Everest Neighborhood Plan

Final Draft Everest Plan with strikethrough and underlined text

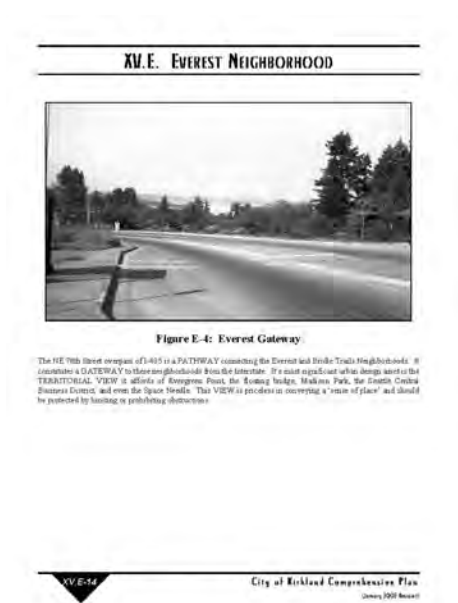
Delete the photo above with current photo below
